3.0 LIMITING CONDITION FOR OPERATION (LCO) APPLICABILITY

The information in this section of the reference ABWR DCD, including all subsections, is incorporated by reference with the following departure.

STP DEP 16.3-1

Figure B 3.3.1.4-1 ESF Actuation Channel Structure for Containment Isolation, ESF Support

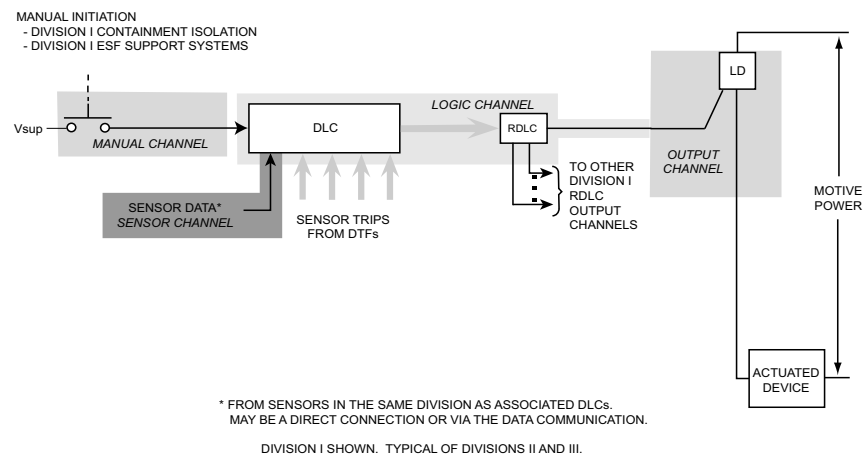
The channel structure for the channel types covered by this LCO are depicted in Figures B 3.3.1.4-1 through B 3.3.1.4-45. The channel structure in these Figures is similar with the basic structure as shown in Figure B 3.3.1.4-1. The channel characteristics shown in the ~~Figures Figure B-3.3.1.4-1~~ are:

Figure B 3.3.1.4-1 (Containment Isolation, ESF Support Systems):

STD DEP T1 3.4-1

Figure B 3.3.1.4-2 ESF Actuation Channel Structure for LPFL B, C, HPCF B, RCIC

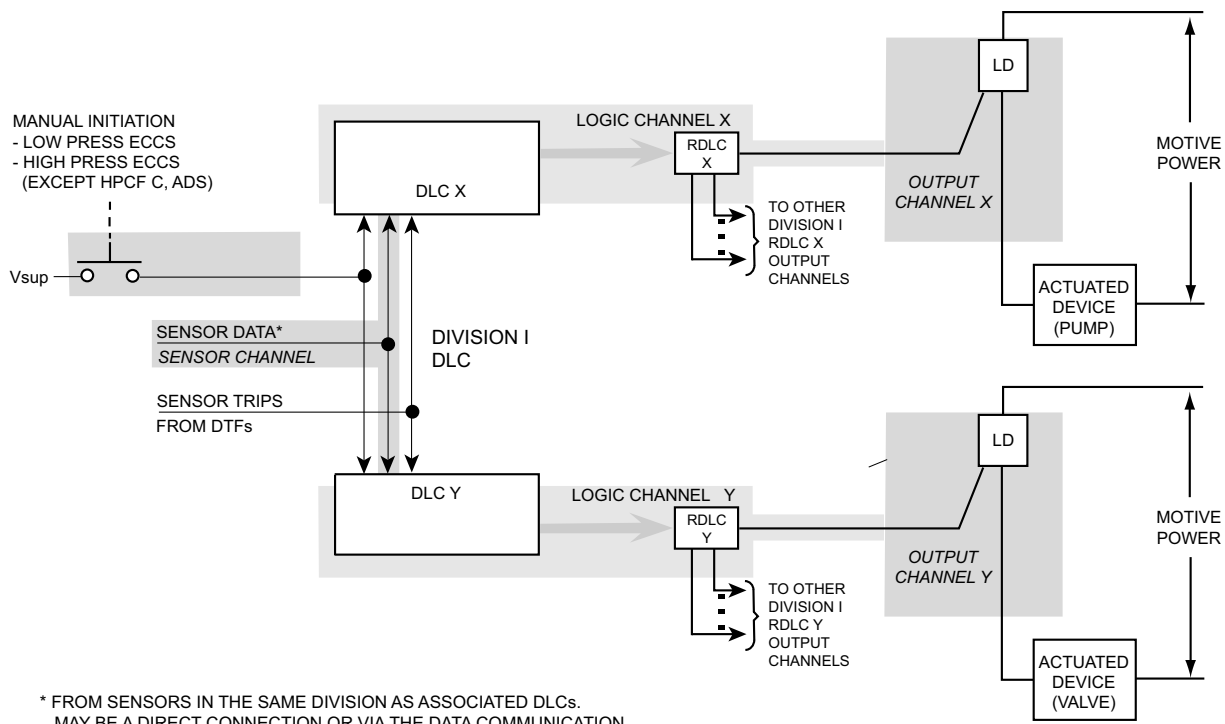
- ~~Figure B 3.3.1.4-2 uses the SLU 3/4 pair and applies only to divisions I and II.~~
- ~~Figure B 3.3.1.4-3 shows the hardwired manual channel for HPCF C which applies only to division III.~~
- ~~Figure B 3.3.1.4-4 shows the ADS which has manual initiation switches, one ATWS Manual ADS Inhibit, and no LOGIC CHANNEL bypass capability.~~

STD DEP T1 3.4-1

Figure B 3.3.1.4-3 ESF Actuation Channel Structure for HPCF C

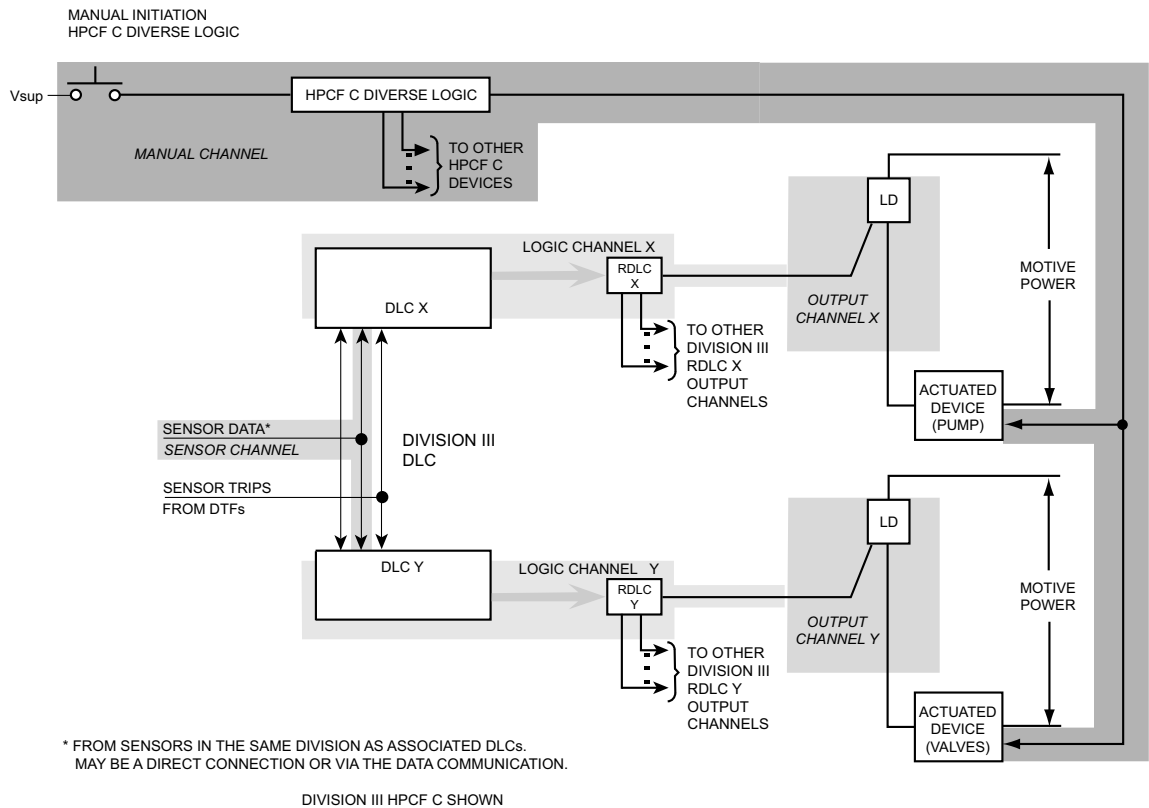
- Figure B 3.3.1.4-3 shows the hardwired manual channel for HPCF C diverse logic which applies only to division III.
- ~~The separate contacts from a~~ A single switch operator ~~are shown as~~ provides the manual initiation signal to ~~separate both~~ manual initiation channels, except HPCF C.

The HPCF C Diverse Logic Manual Initiation channel completely bypasses the SSLC channels (see figure B 3.3.1.4-3) and provides direct control of the actuated devices. One manual pushbutton causes HPCF C to align for injection and initiates the pump start sequence.

STD DEP T1 3.4-1

Figure B 3.3.1.4-4 ESF Actuation Channel Structure for ADS

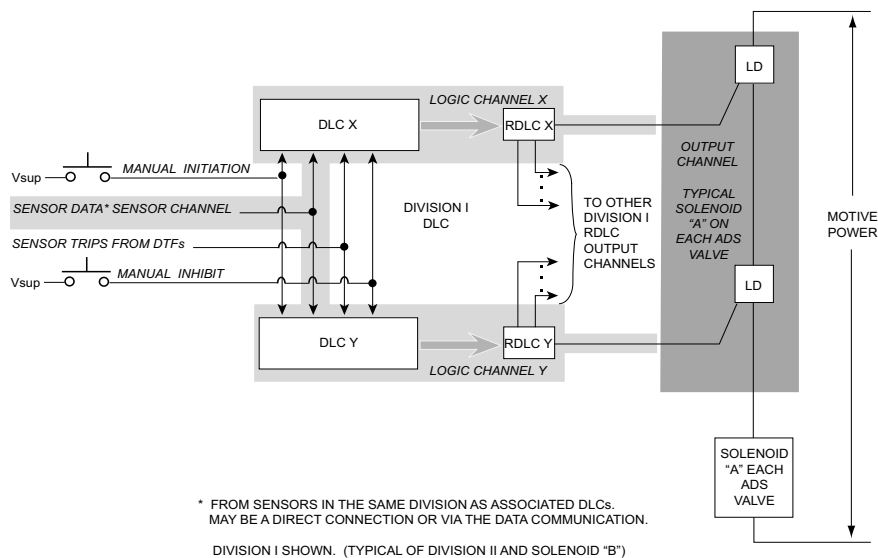
The ATWS Manual ADS Inhibit push button channels introduce signals into the ADS logic to provide manual ADS inhibit capability that is redundant to the automatic SENSOR CHANNELS. There is one push button for each ADS division trip system. ~~Each pushbutton has two contacts. Each member of the SLU pair~~ Both DLCs used to implement ADS within a division acquire data from ~~one of the contacts on the switch in its division~~ (see Figure B 3.3.1.4-4).

STD DEP T1 3.4-1

Figure B 3.3.1.4-5 ESF Actuation Channel Structure for RCW/RSW Isolation

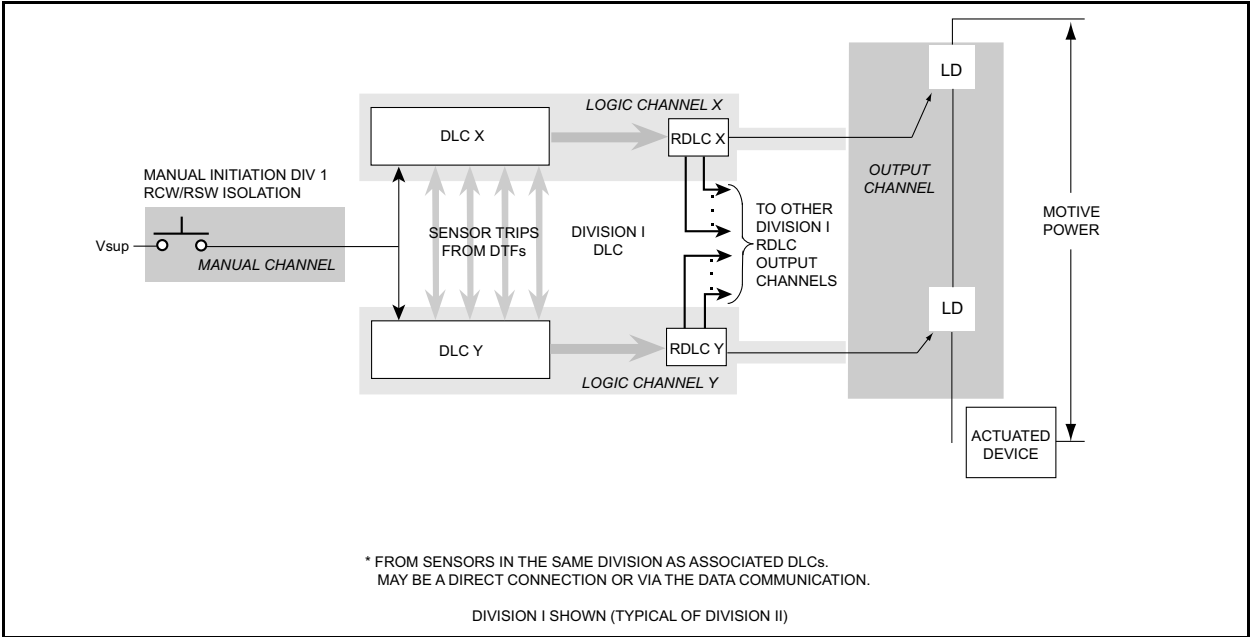
Figure B 3.3.1.4-5 (RCW/RSW Isolation):

STD DEP T1 3.4-1

Figure B 3.3.4.1-1 ATWS and EOC-RPT Instrumentation Channels

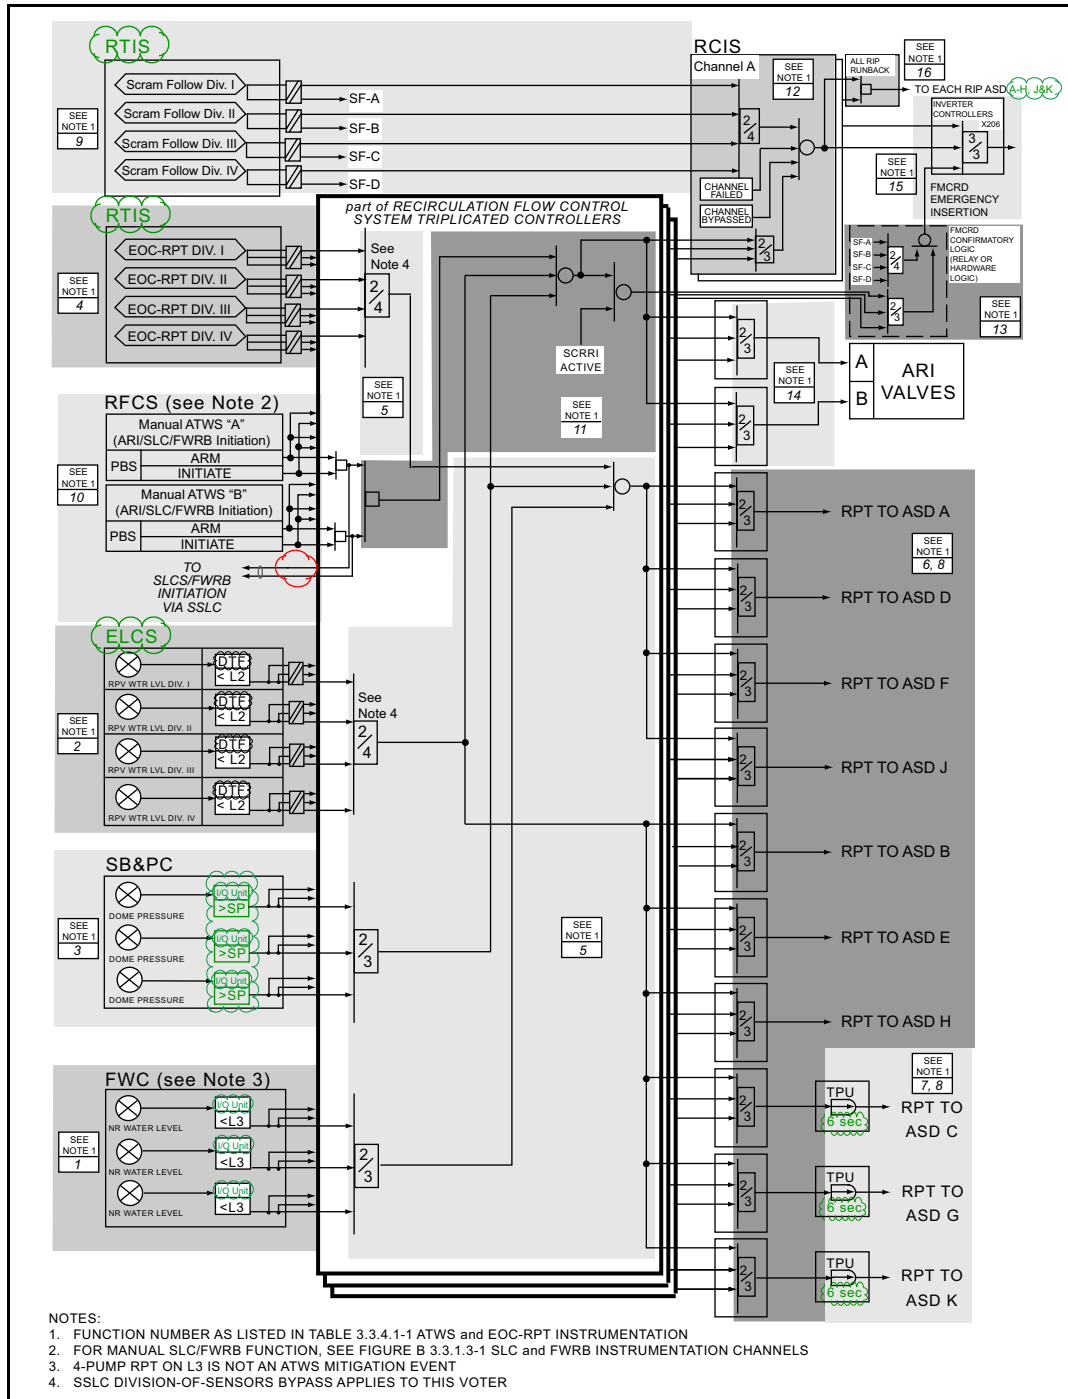
STD DEP T1 3.4-1
